Reviewer 1

The comments of Reviewer 1, along with our responses to each comment, are included below:

"This work presents a boundary optimal control strategy for axial tubular reactors with first-order irreversible chemical reaction incorporating a delayed recycle stream. The mathematical description takes the form of a system of coupled parabolic and hyperbolic PDEs. An infinite-dimensional approach is applied to derive a linear quadratic regulator with and without observer. Numerical studies show that the proposed controller is able to stabilize the system. The manuscript is clear and well written and addresses a challenging control problem in chemical engineering. The following comments and suggestions may improve the presentation so that it is considered for publication."

Figure 1: Concentration profile along the recycle stream

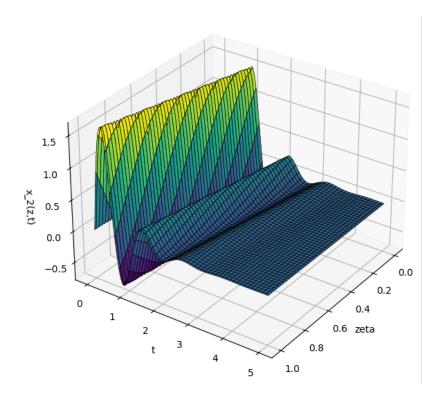
- 6. Page 7 " $x_2(\zeta, t)$ is introduced as a new state variable to account for the concentration along the recycle stream"
 - Why is x_2 a function of ζ ? How does x_2 change across the recycle? What kind of law does it follow? To me, it seems like x_2 only changes with respect to time

We have assumed that along the recycle stream, the flow of the reactant belongs to the class of pure transport PDEs. This is the case when the diffusion term and the reaction term become negligible compared to the convective term, and the state variable x_2 is merely being transported along the recycle stream. Nevertheless, this still implies that x_2 is a function of ζ and t. Concentration profile along the recycle stream has not been presented in the original submission as we believe it is not the focus of this work. However, for the reviewer's reference, it is included here in the response as shown in Fig. 1.
